**Harker Heights
Planning and Zoning
Commission
Meeting & Workshop**

PRELIMINARY PLAT OF: STONE LAKE TRAILS F.M. 2410, Bell County Rural, Texas

**MASTER UTILITY PLAN OF:
STONE LAKE TRAILS**
134.832 ACRES 5,873,300.37 S.F.
117 LOTS, 3 BLOCKS AND 4 TRACTS INCLUDING:
11,157.41 L.F. OF NEW STREETS AND 698,422.79 S.F. OF R.O.W.
JOHN HUGHES SURVEY, ABSTRACT #379, BELL COUNTY TEXAS
A SUBDIVISION IN THE ETJ CITY OF HARKER HEIGHTS, BELL COUNTY TEXAS

Plat Distributed to HH Staff: June 3, 2021

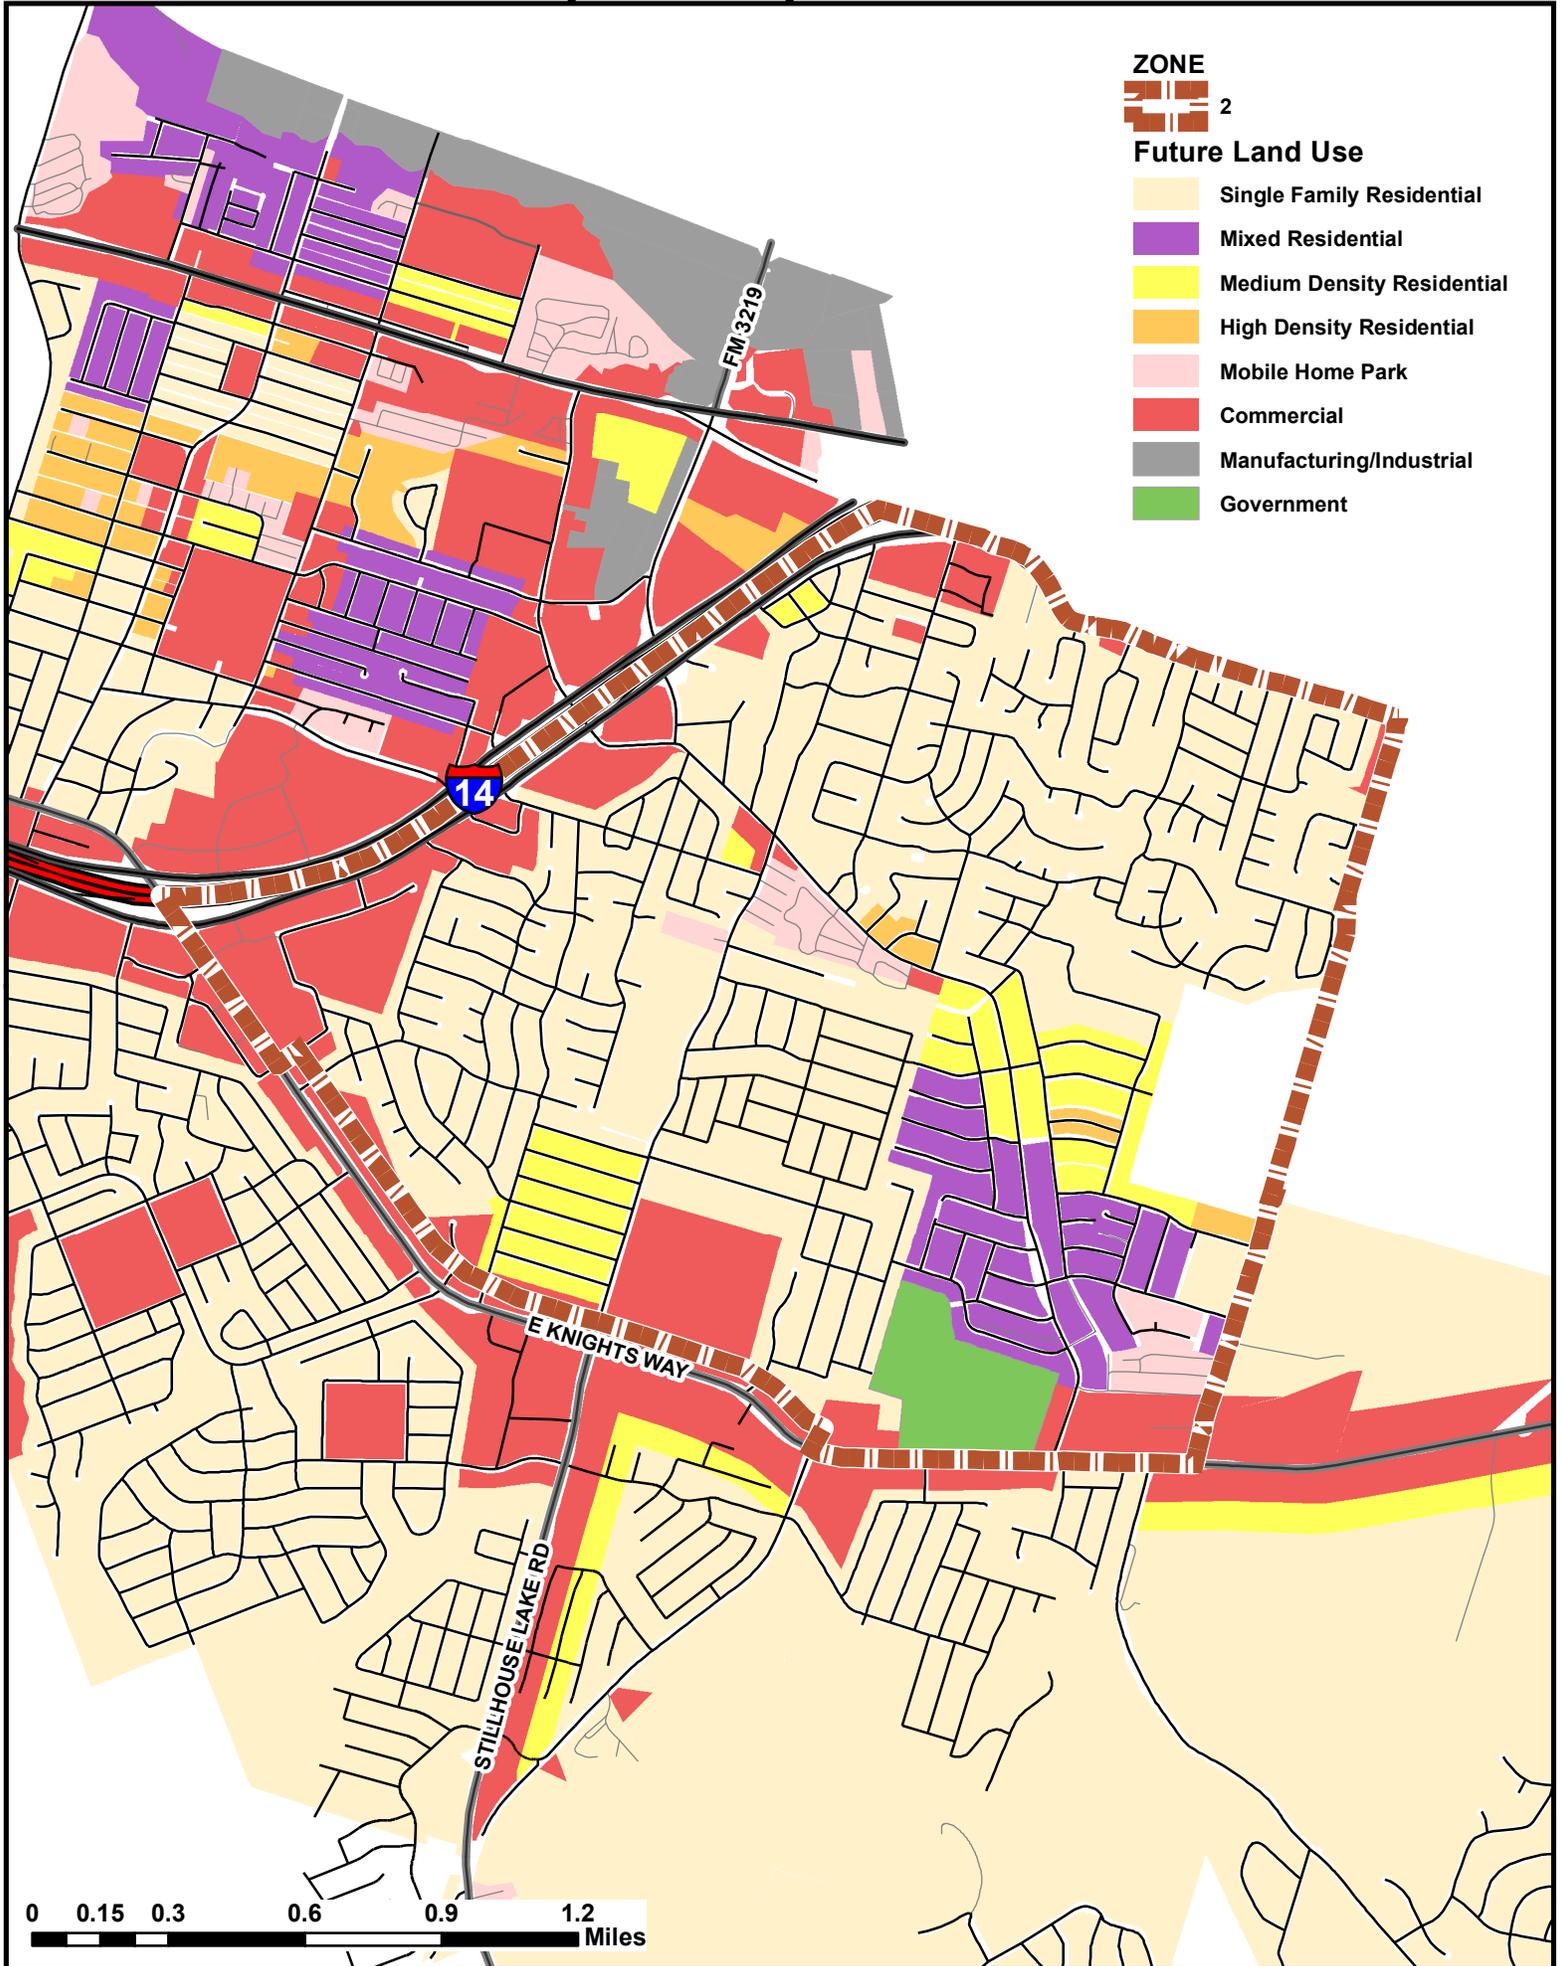
1. TxDOT requests a one-foot non-access easement to be placed along the entire frontage being broken only at the existing access location.

[A one-foot non-access easement has been provided with a single 30' access point.](#)
